Economic Commission for Europe**Inland Transport Committee****World Forum for Harmonization of Vehicle Regulations****Working Party on General Safety Provisions****122nd session**

Awareness of the proximity of Vulnerable Road Users**UN Regulation No. 46 (Devices for indirect vision)****Proposal for the 05 series of amendments of UN Regulation
No. 46****Submitted by the expert from Germany and by the expert from the
International Organization of Motor Vehicle Manufacturers ***

**Figure 1
 Example for the measurement by maximum variation**

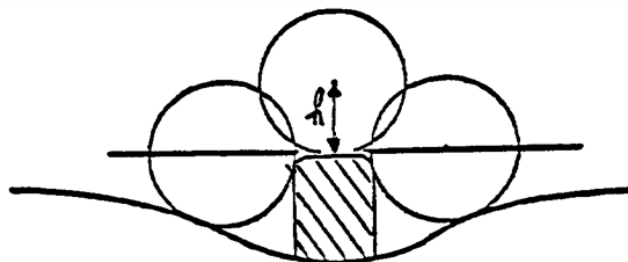
"6.2.2.1.2.2. If the dimension of the projection of a component which is mounted on a surface other than convex cannot be determined by simple measurement, it shall be determined by the maximum variation of the distance of the centre of a 100 mm diameter sphere from the nominal line of the panel when the sphere is moved over and is in constant contact with that component. Figure 1 shows an example of the use of this procedure.

In the UN Regulation No. 46 actually we have different requirements of the outer radius for a mirror system for indirect vision and a camera-monitor-device for indirect vision. For some safety functions (e.g. rain deflector, wind deflector) on the camera-monitor device, it would be useful to have the same requirements as a mirror system.

In the area of camera lenses special deflector geometry is necessary to improve the image quality captured by the camera. These deflectors are influencing or preventing air turbulences and through this are keeping rainwater and dirt particles away from the optical system.
